Fulmer St CDR Presentation

STONEMONT FINANCIAL INDUSTRIAL
1685 & 1719 FULMER STREET
OPA# 885000380 & 885000013
CITY OF PHILADELPHIA, PENNSYLVANIA

NORTH EXTERIOR ELEVATION
SCALE: 1" = 20'-0"

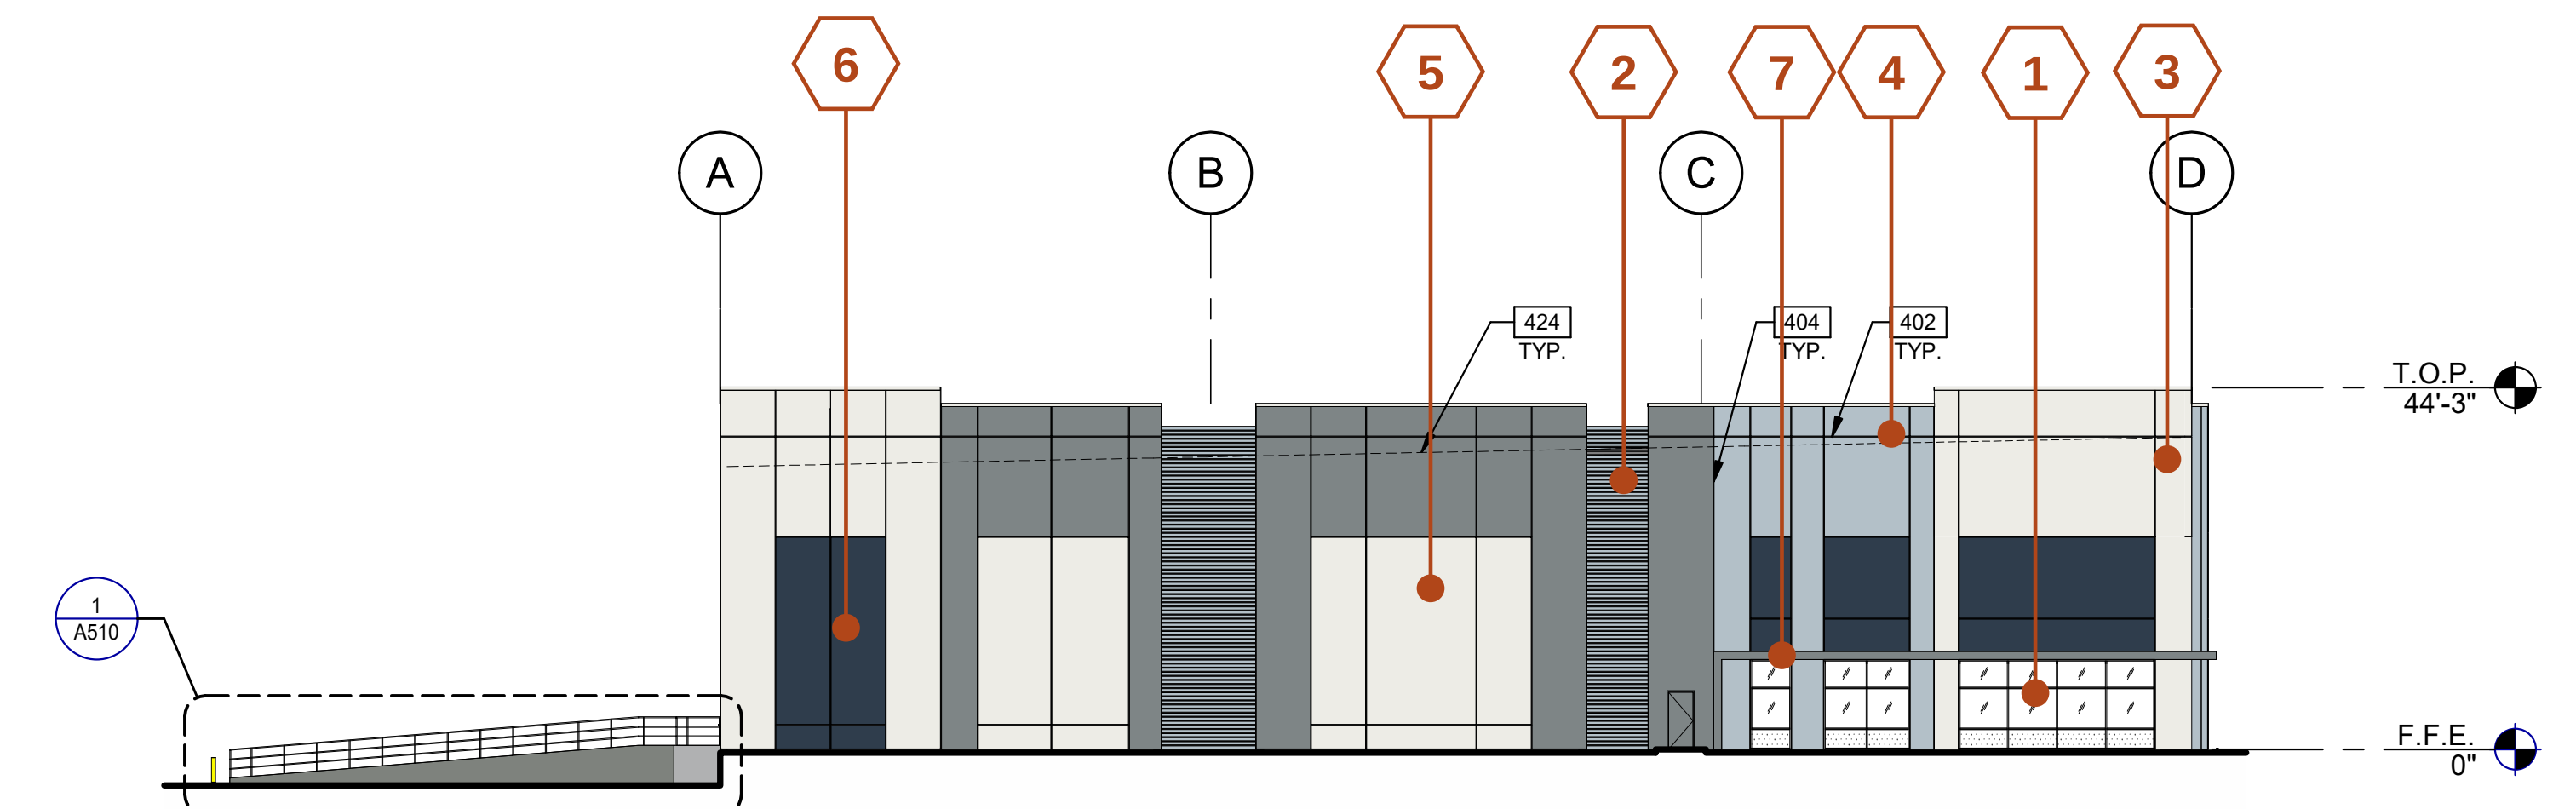
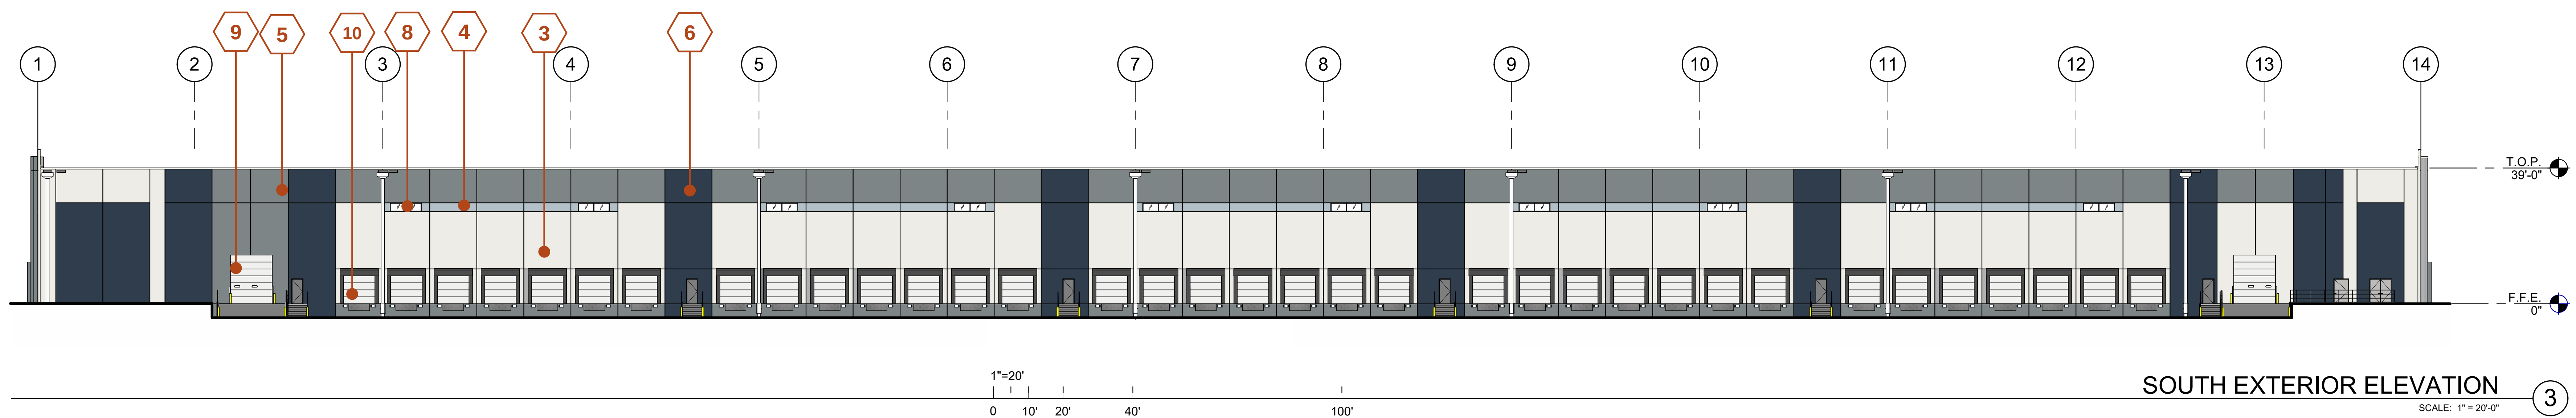
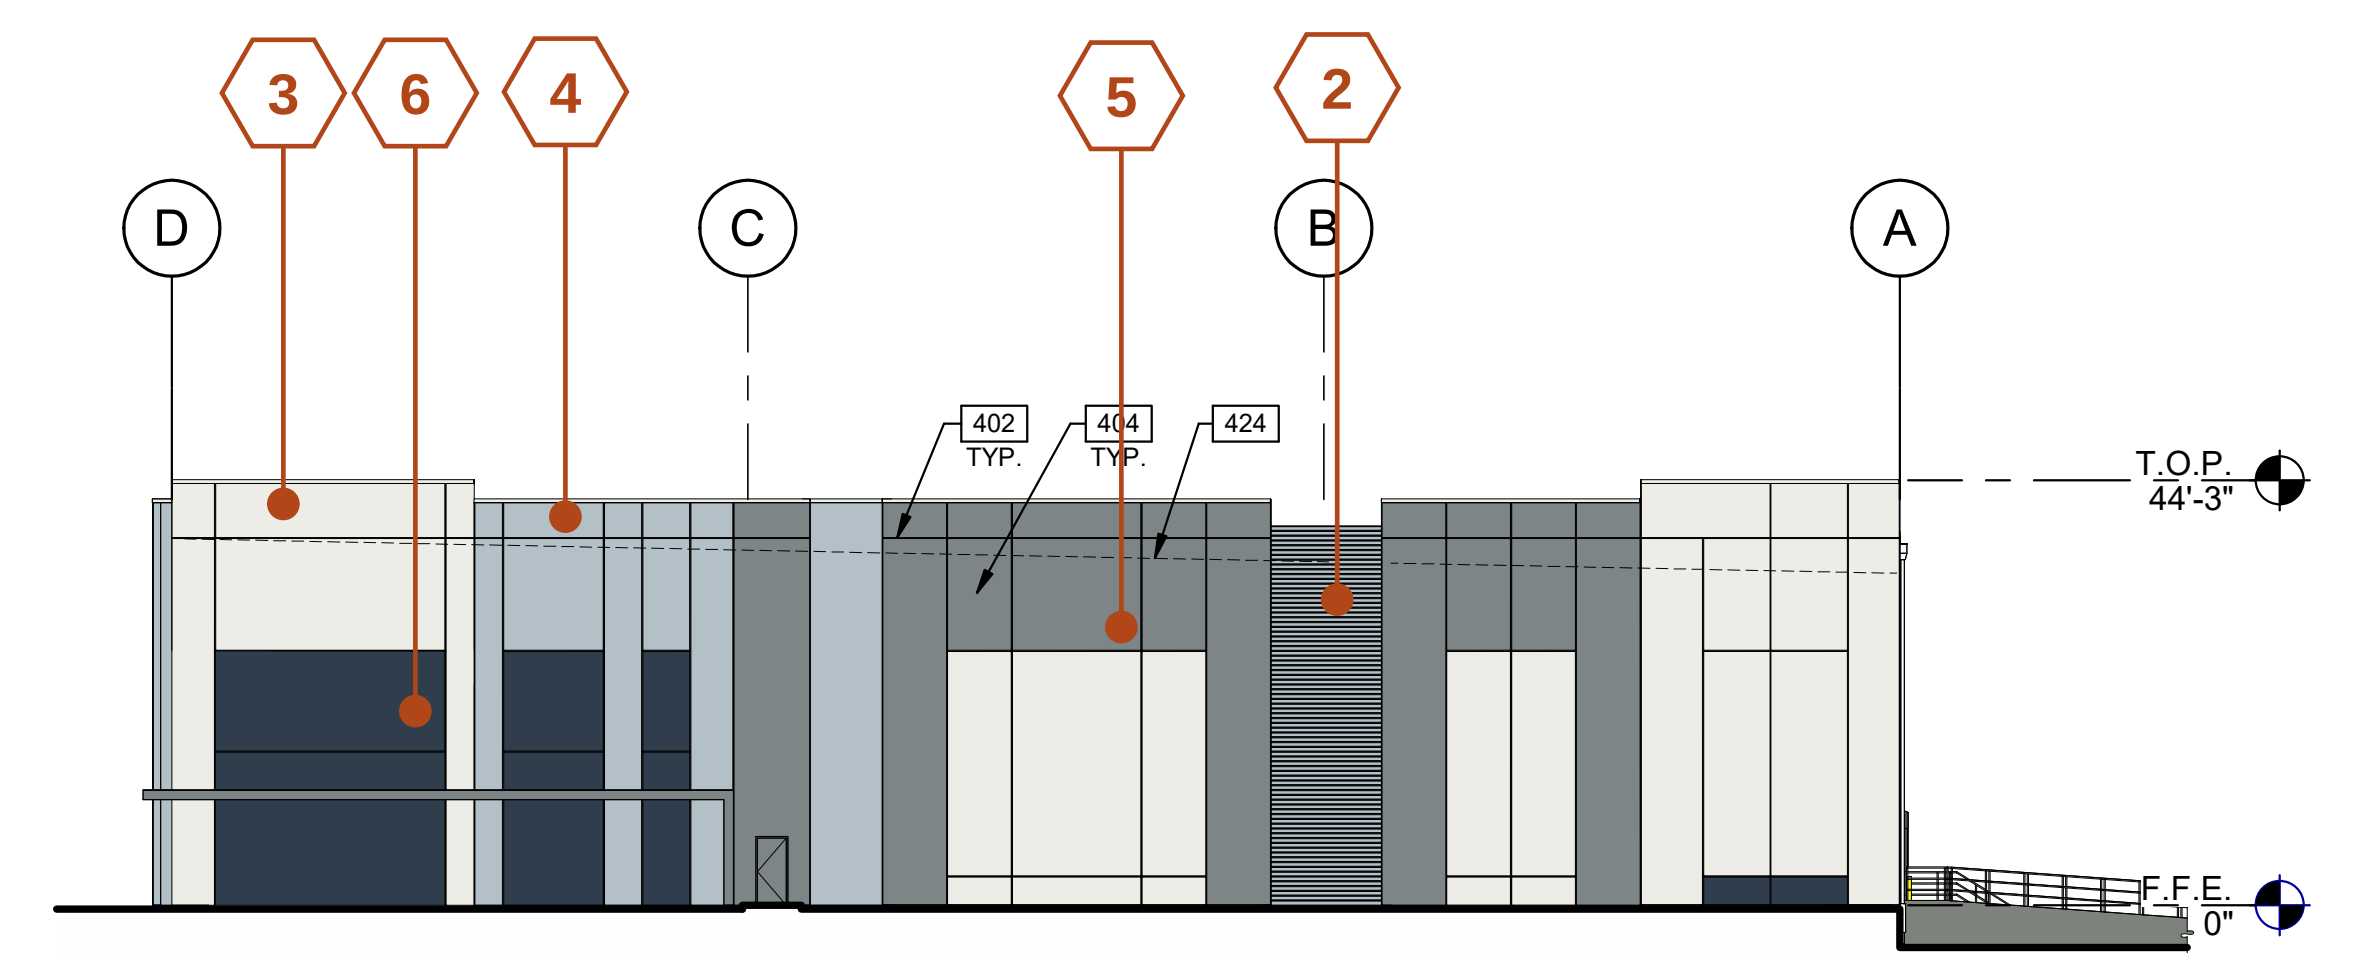
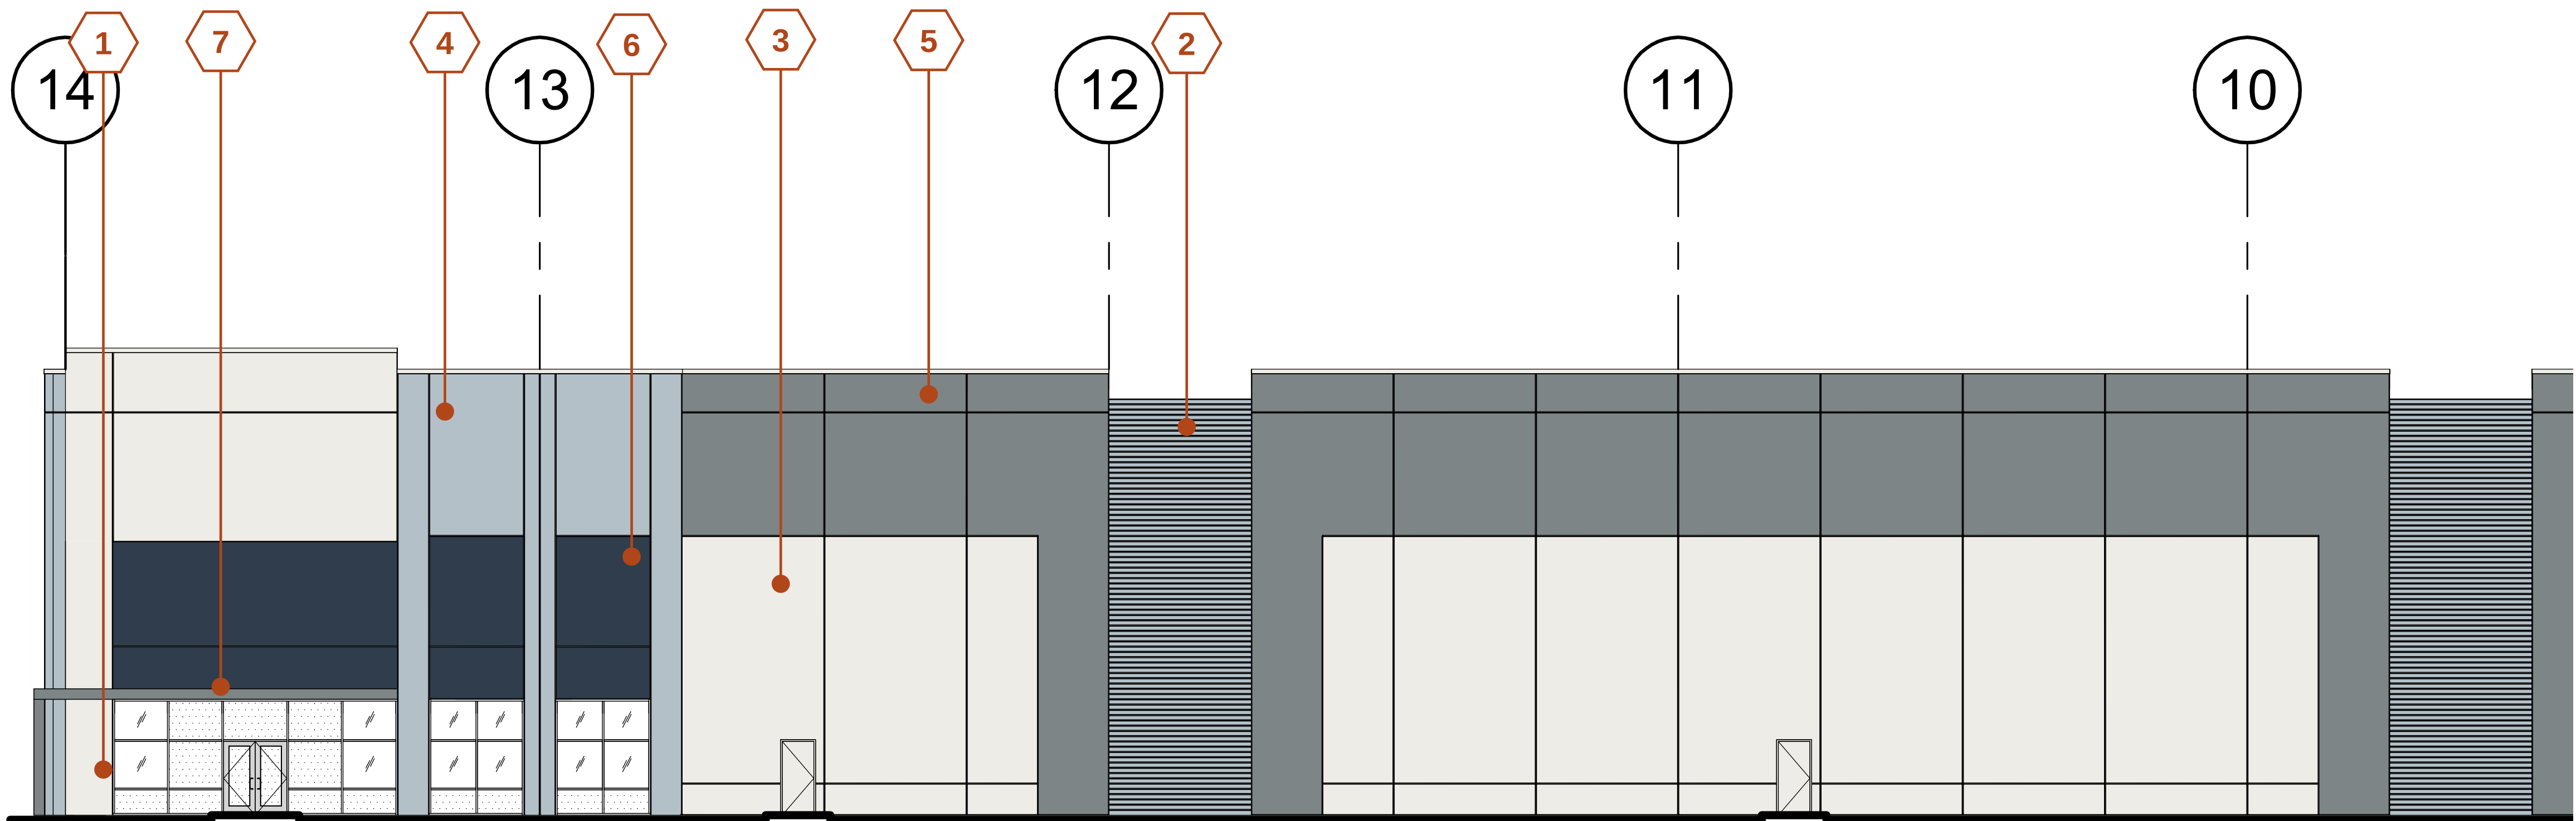
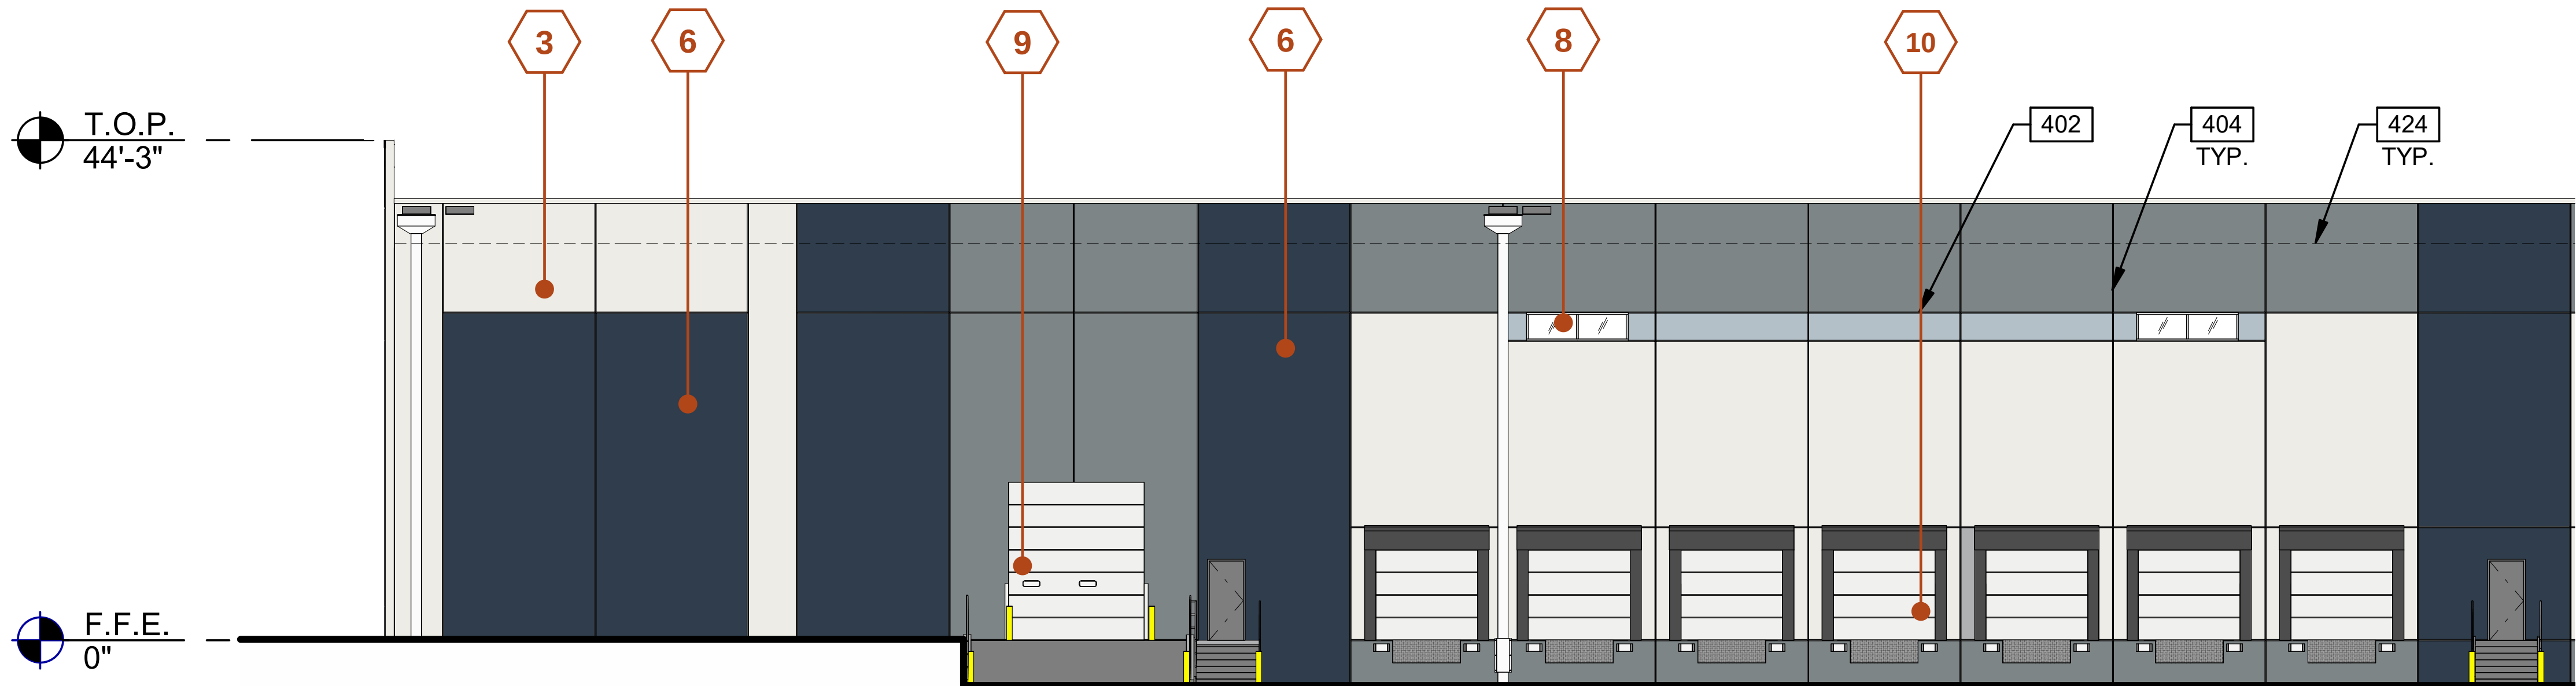
Building Design Comments	
12	Add transparency where possible. We designed the building with aesthetics in mind, with wall panel changes, detailed paint design, material changes, and intentionally designed glass features bringing in the light at the correct locations.
13	Make the main entrance clearer by painting it a different color. Our current elevations already differentiate tenant entries framed with the light blue color scheme (see clip below). We will also use signage as an indicator for the main entry.
Sustainability Comments	
14	Add Electric Vehicle parking spots. We can designate car parking spaces to be EV ready.
15	Reduce the amount of parking and increase vegetation. The actual needs of the building are in line with the provided parking, including the trailer parking spaces. Landscape islands with trees were previously added to mitigate the impact of the paving.
16	Add solar panels. The building will be designed for solar ready capabilities.
